City of El Paso – City Plan Commission Staff Report

Case No:	SUSU14-00023 – Kern View Estates Unit Two Replat A
Application Type:	Resubdivision Combination
CPC Hearing Date:	August 28, 2014
Staff Planner:	Nelson Ortiz, (915) 212-1606, ortiznx@elpasotexas.gov
Location:	East of Stanton and North of San Mateo
Acreage:	15.5757 acres
Rep District:	1
Existing Use:	Vacant
Existing Zoning:	R-3 / P-R 1/c (Residential / Planned Residential/condition)
Proposed Zoning:	R-3 / P-R 1/c (Residential / Planned Residential/condition)
Nearest Park:	Mission Hills Park (.23 mile)
Nearest School:	Mesita Elementary School (.70 mile)
Park Fees Required:	$83,570.00
Impact Fee Area:	N/A
Property Owner:	Piedmont Group, LLC
Applicant:	Piedmont Group, LLC
Representative:	Brock & Bustillos, Inc.

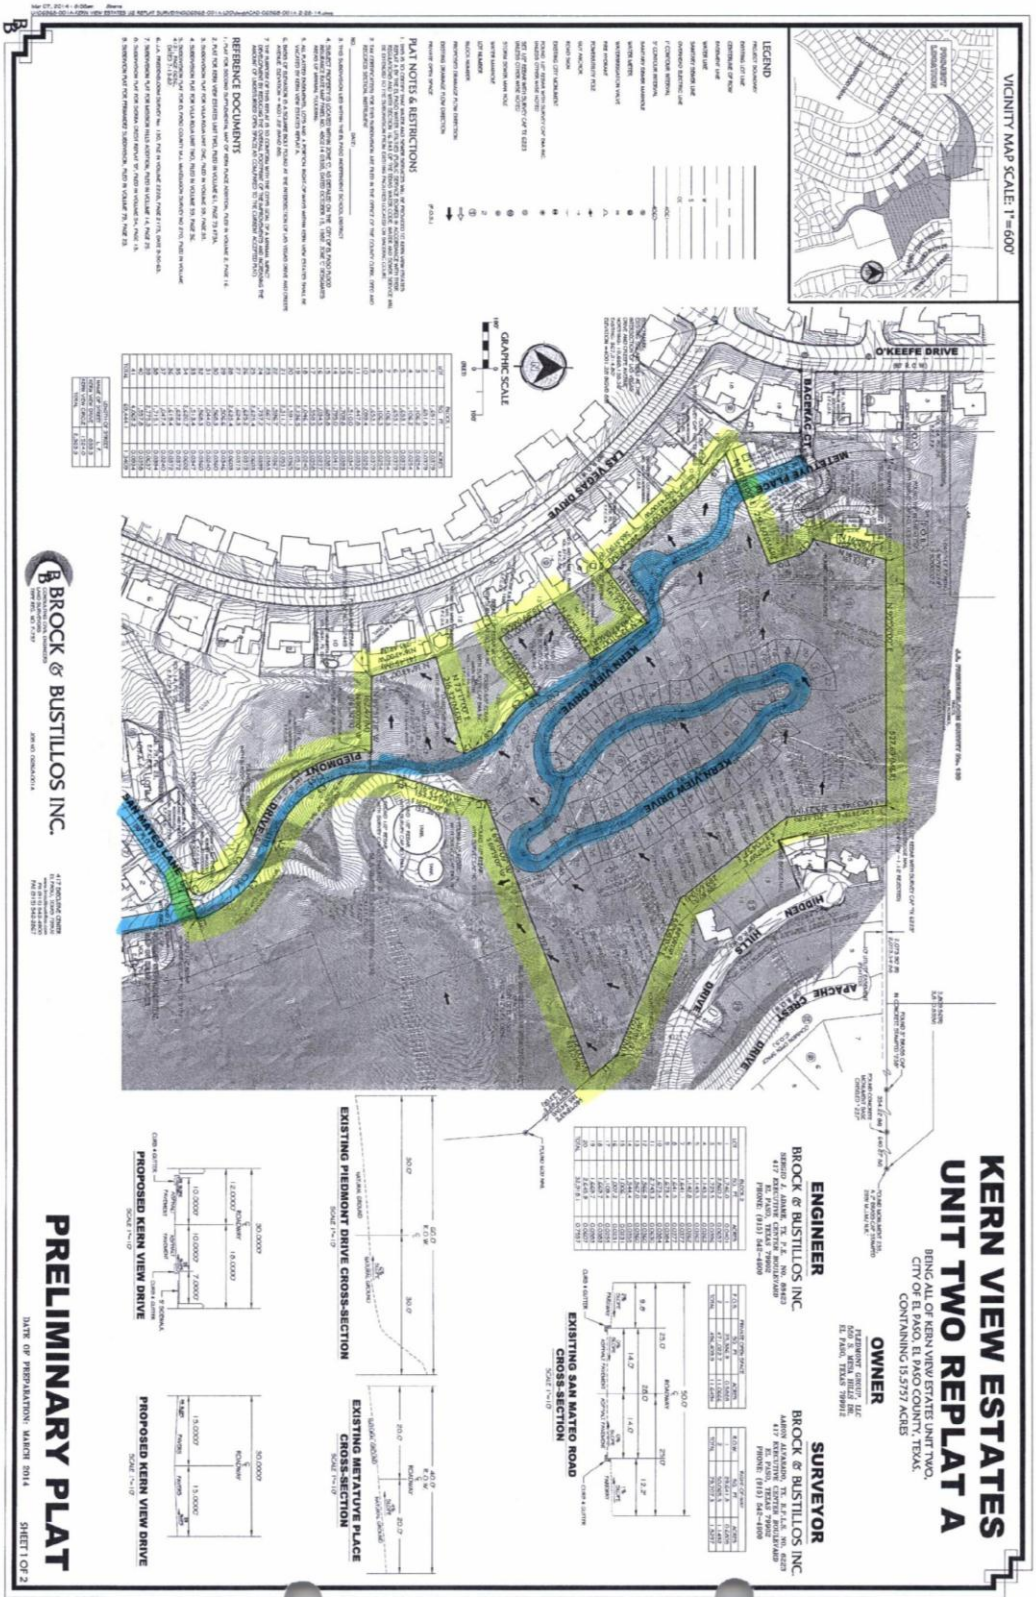
1. Verify line of sight for proposed monuments along drives.
2. On the street cross-sections, need to label the slope and direction.
3. Provide cross section for proposed future private Piedmont Drive.
4. Show proposed drainage flow patterns and contours on the preliminary plat. Identify the discharge location for all storm-water runoff.
5. Verify safe conveyance of the existing watercourse through the developed subdivision and show that all downstream storm-water management facilities have sufficient capacity to carry the additional runoff.

6. Provide a note on the plat indicating the entity responsible for maintenance of private drainage easement and private open space.

- Addressing shall be displayed on the plat.

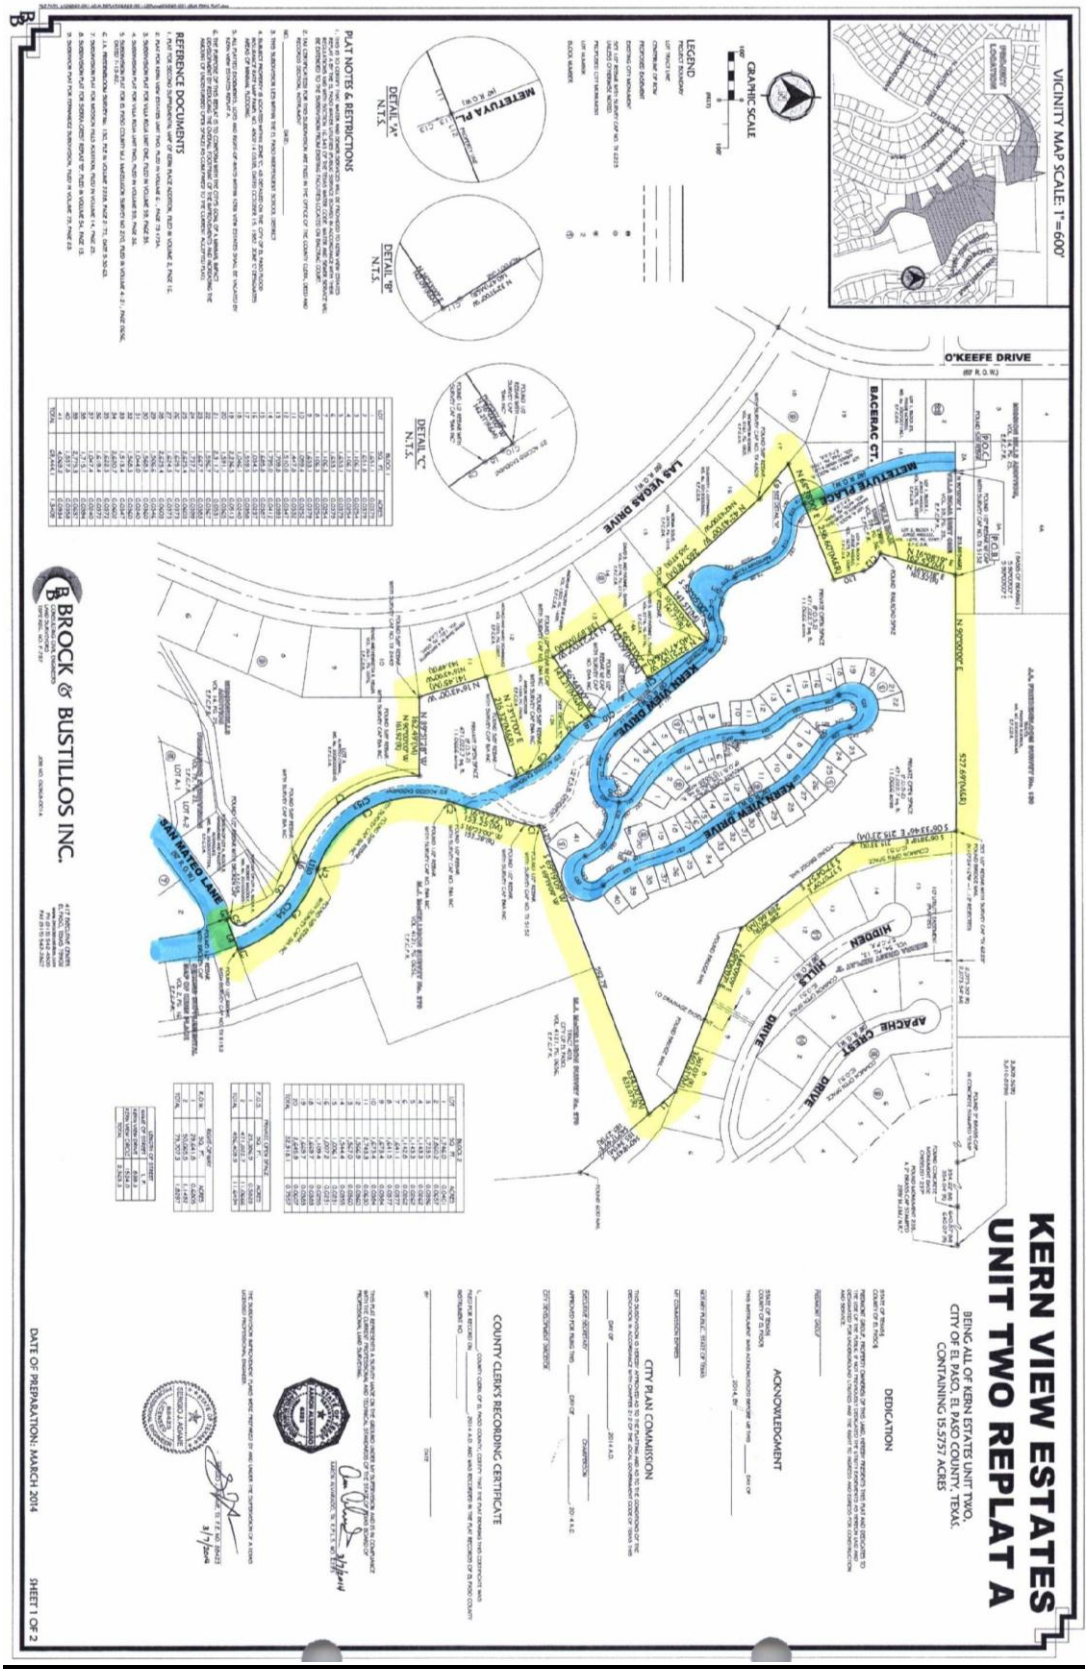
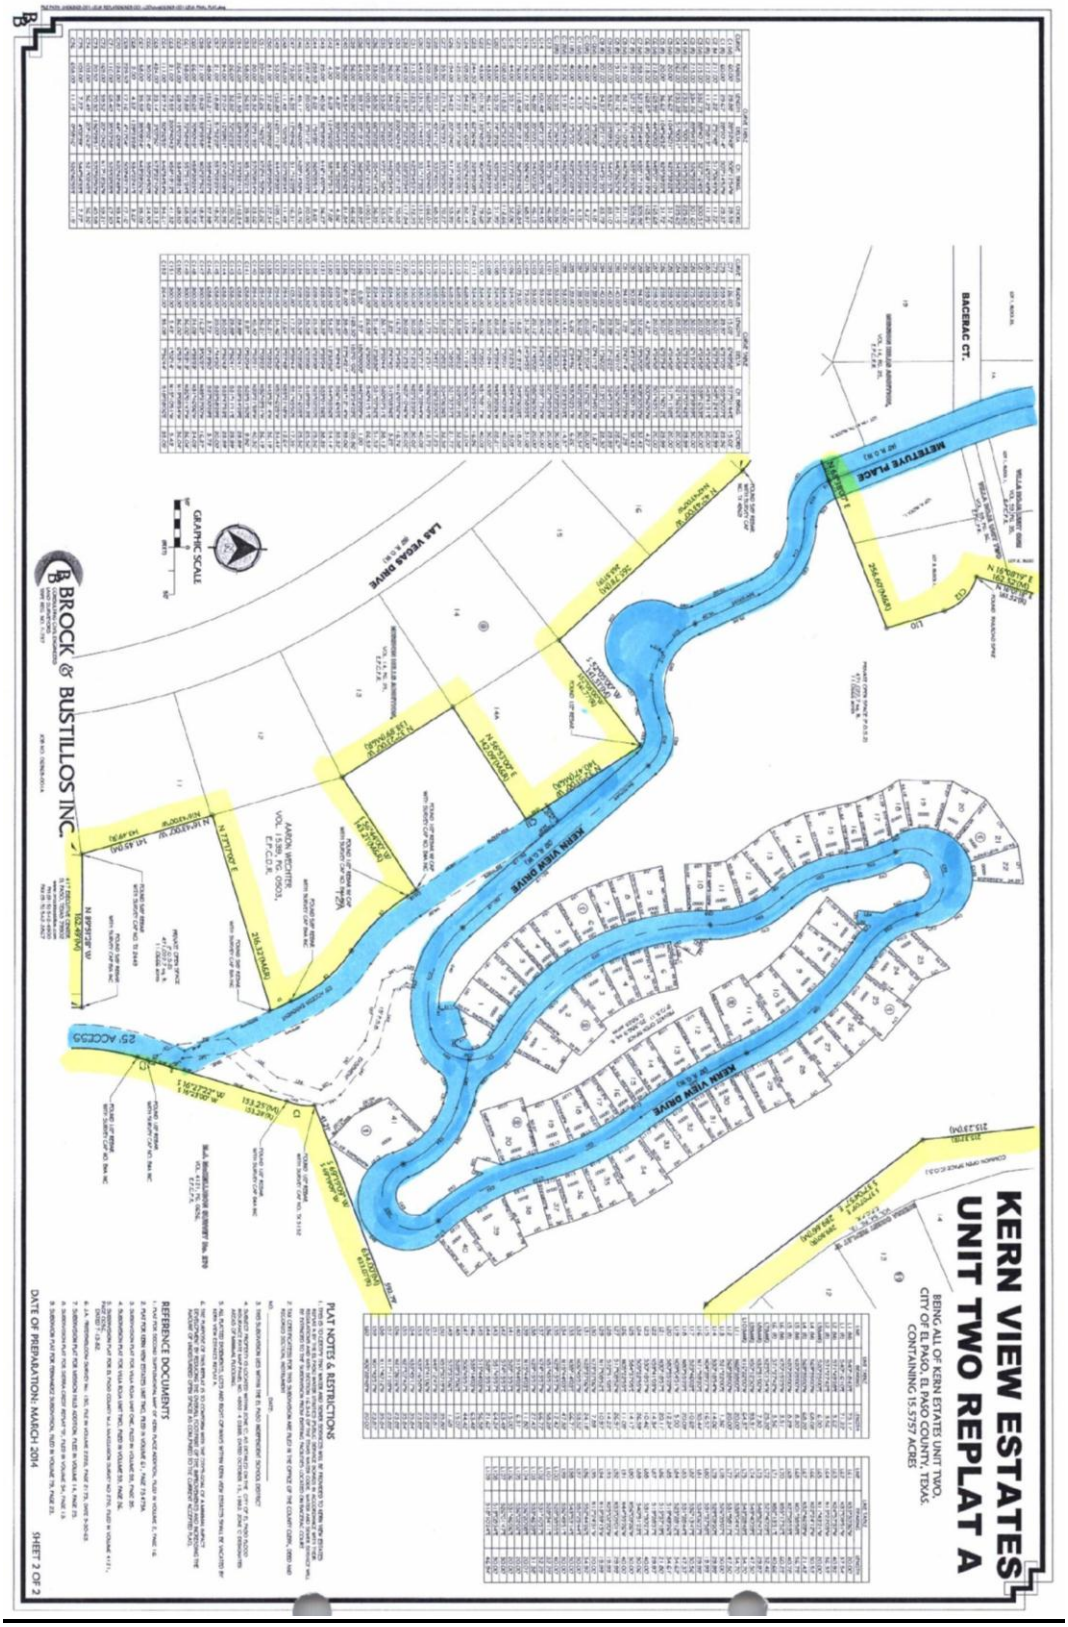
We have reviewed **Kern View Estates Unit 2 Replat "A",** a resubdivision combination plat map and offer Developer / Engineer the following comments:

Please note that this subdivision is zoned "P-R1" meeting the requirements for Residential Mix of Single-family, Two-family, & Multi-family Dwellings use restricted to a maximum of 7 dwelling units per acre however, applicant has submitted preliminary covenants restricting the use to Single-family units therefore, park fees will be assessed based on the following:

1. **If** gross density waiver is granted by the Planning Department or designee and copy of the final recorded covenants is provided restricting the number of dwelling units to one Single-family dwelling unit per residential lot, then applicant shall be required to pay "park fees" in the amount of **$83,570.00** based on Residential requirements calculated as follows:

61 Lots restricted to Single-family dwelling units per lot @ $1,370.0 / dwelling = **$83,570.00**
